PARTS & SERVICE NEWS

REF NO.	AA02103
DATE	March 25, 2002

SUBJECT: INTRODUCTION OF NEW SEAT AND JOYSTICK BRACKET

PURPOSE: To introduce to the field a new air suspension seat and reinforced joystick

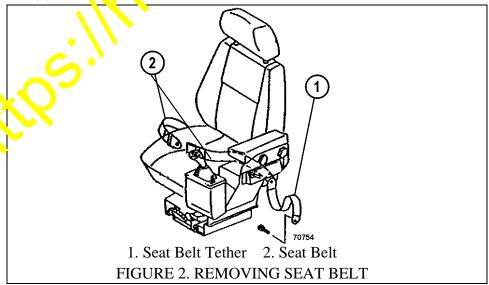
- 1. Disconnect joystick connector (1, Figure 1)
- 2. Remove four bolts (5) and washers (6) from the seat mounting. Adjust the seat position to gain access to all of the bolts.
- 3. Remove seat (3) and plate (8) These components will not be reused.
- 4. Remove seal (2) and seal (7) and discard.

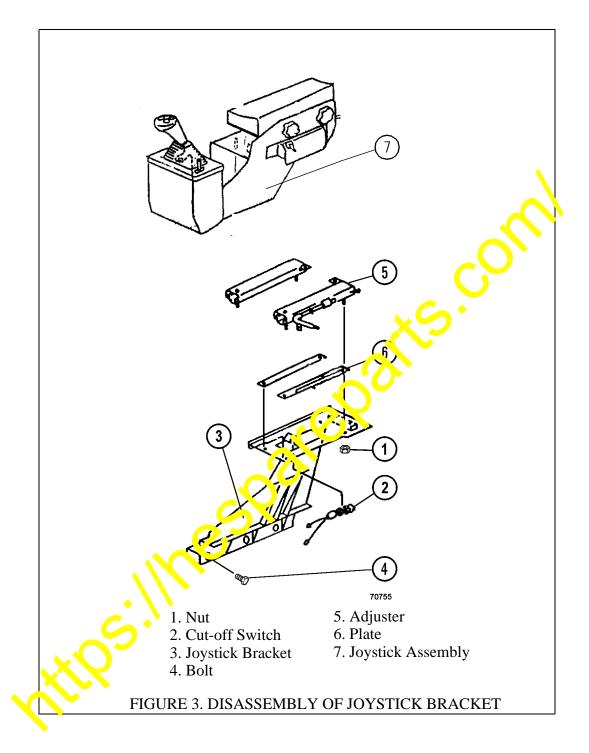
- 5. Remove seat belt (2, Figure 2) and two tethers (1) from the operator's seat. Seat belts, part number 09409-10001, are to be replaced with seat belt, 421-960-A520.
- 6. Disconnect the two tethers from the cab mounting structures and discard the bolts and washers.

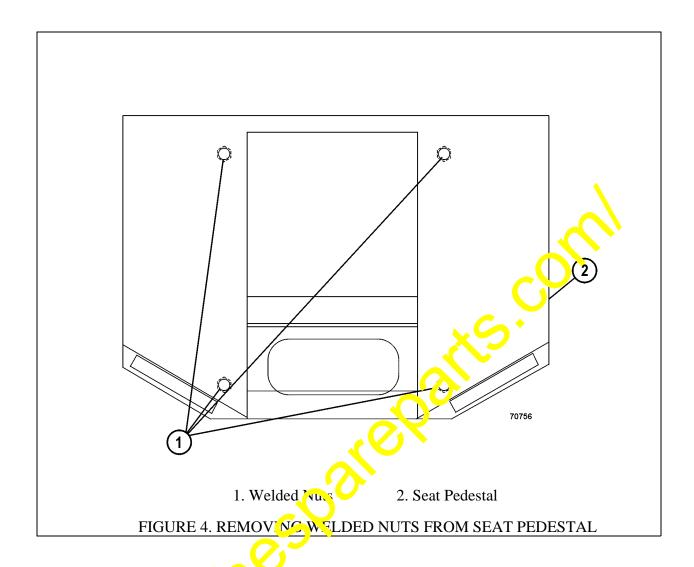
- 7. Remove four nuts (1, Figure 3) from the joystick bracket and remove joystick assembly (7), adjusters (5), and plates (6).
- 8. Disconnect cut-off switch (2) and remove from joystick bracket (3).
- 9. Remove three bolts (4) and remove the joystick bracket.

- 21. Place plates (6, Figure 3), adjusters (5), and joystick ass mily (7) into position on the joystick bracket. Install four nuts (1) to secure the assembly

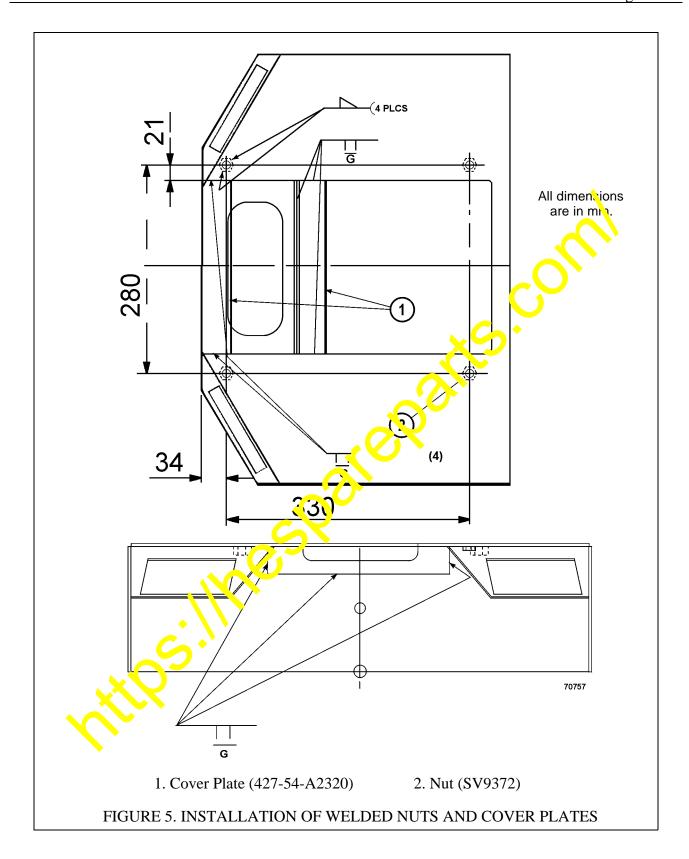
- 10. Remove four welded nots (1, Figure 4) from seat pedestal (2).
- 11. Weld the open holes until entirely filled, and grind smooth.

- 12. Drill four, 12.3 mm (0.484 in.) holes according to the dimensions in Figure 5.
- 13. Weld four nuts (2, Figure 5) to the bottom side of the drilled holes.
- 14. Weld cover plates (1) to the dimensions shown in Figure 5.

FIGURE 6. ASSEMBLY OF SEAT COMPONENTS

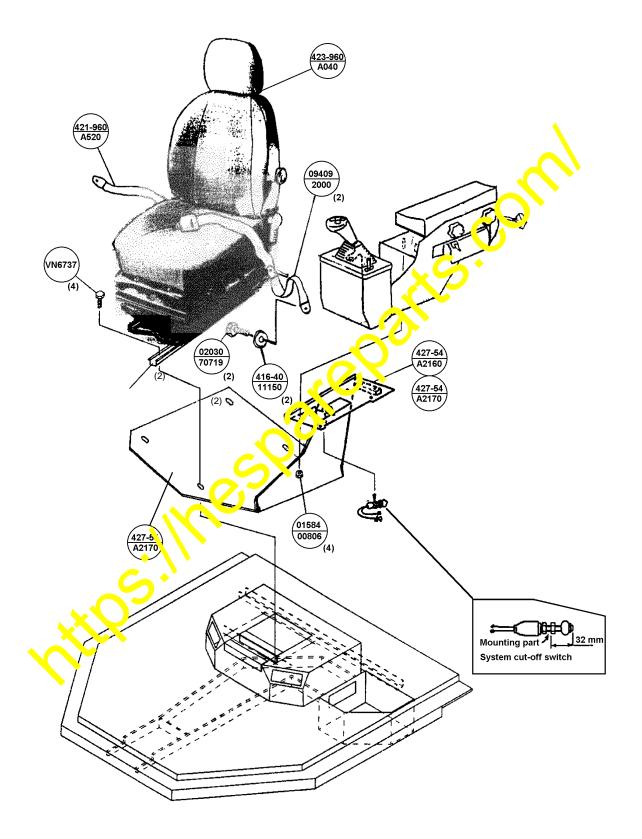
- 16. Tighten bolts (3, Figure 7) to a torque of 45 ft.lbs. (6.2 kgm).
- 17. Position new joystick bracket to the seat pedestal and place the new operator's seat on top of the bracket. Refer to Figure 6. Align the holes and install four new bolts (VN6737). Adjust the seat to gain access to all of the holes. Tighten the bolts to a torque of 21 ft.lb. (31.3 kgm).

- 20. Reinstall the existing cutout switch. Refer to Figure 6 for the proper installation dimension. Connect the female lead to CN11 on the joystick harness. Connect the male lead to CN12 on the joystick harness.

FIGURE 7. SEAT BELT INSTALLATION

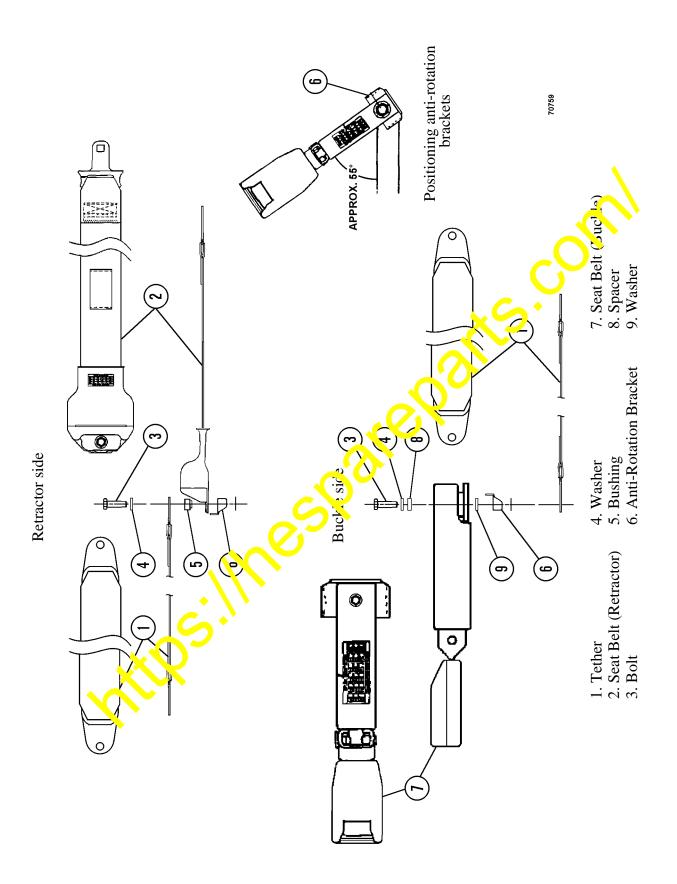
- 15. Install seat belt assembly (421-960-A520) to the operator seat. Refer to Figure 7 for correct installation of components. Note the correct position of the anti-rotation bracket (6).
